**EXPEDITED**  
**HISTORIC PRESERVATION COMMISSION STAFF REPORT**

<b>Address:</b>	3924 Baltimore St., Takoma Park	<b>Meeting Date:</b>	3/14/18
<b>Resource:</b>	Primary-One Resource Kensington Historic District	<b>Report Date:</b>	3/7/18
<b>Review:</b>	HAWP	<b>Public Notice:</b>	2/28/18
<b>Case Number:</b>	31/06-18C	<b>Tax Credit:</b>	n/a
<b>Applicant:</b>	Adeline Vanderver	<b>Staff:</b>	Dan Bruechert
<b>Proposal:</b>	Accessory Structure Removal

Photo 4  
Sagging hip beam

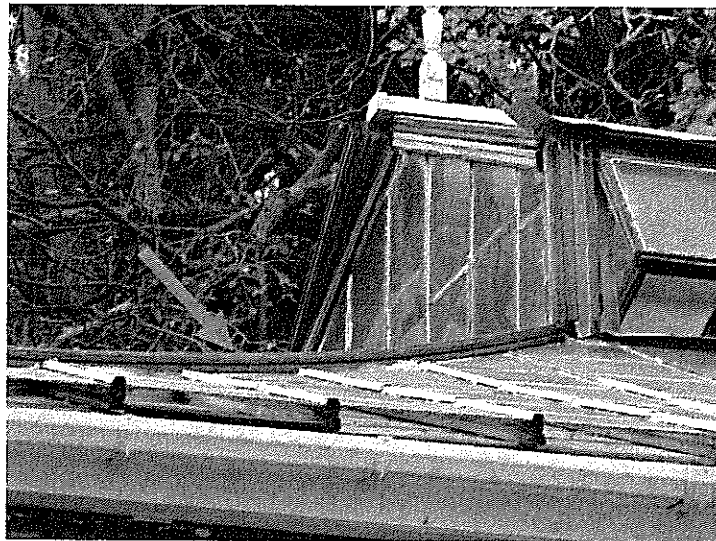
Hip beams are constructed in a similar manner to the rafters except that 3 of the small wood sections are used. All of the hips are exposed to the weather and have sagged significantly and show signs of rot (see photos 4 and 6).

Photo 5  
Sagging rafters

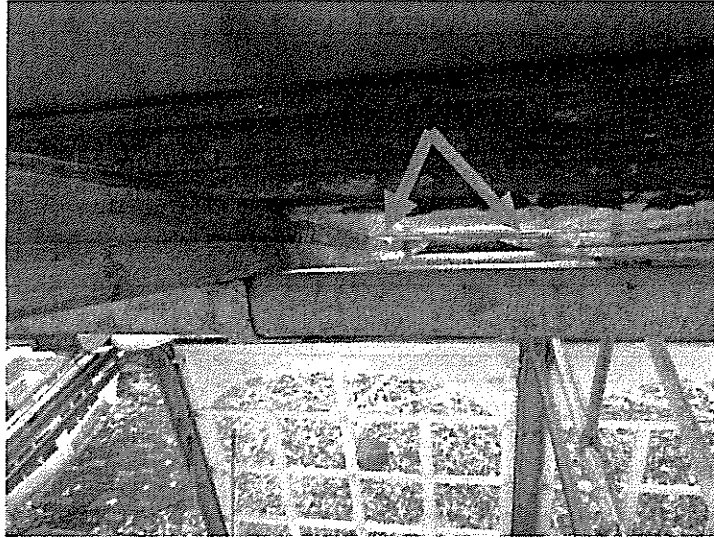
The roof rafters are two 1¾" wide, 2¼" tall wood members set atop one another and spaced 17 inches apart. Each member supports a layer of ¼" thick glass so that there is a sandwich made of two glass panels. The rafters are rabbeted to support the long edges of the glass roofing that sit in between adjacent rafters. It is not known how the glass is held in place. Originally, the tops of the rafters had small lengths of metal flashing that kept rainwater off the wood and out of the glass joint. The majority of those pieces of metal flashing have disappeared (see photo 3) exposing the wood to rainwater and causing rot. Furthermore, the wet conditions have also caused the members to sag (see photo 5).

Photo 9  
Collapsing wall

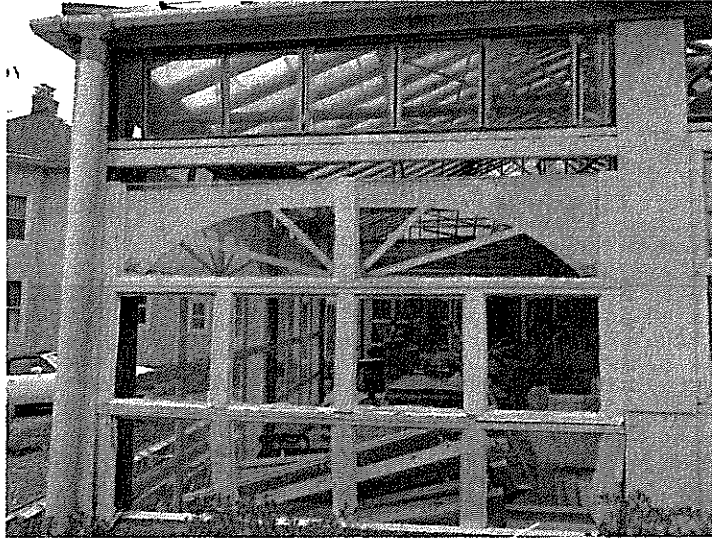
The wood at the northwest corner of the garage has rotted (see photo 8) and two of the three garage doors are rotting and in danger of losing their glass (see photo 9).
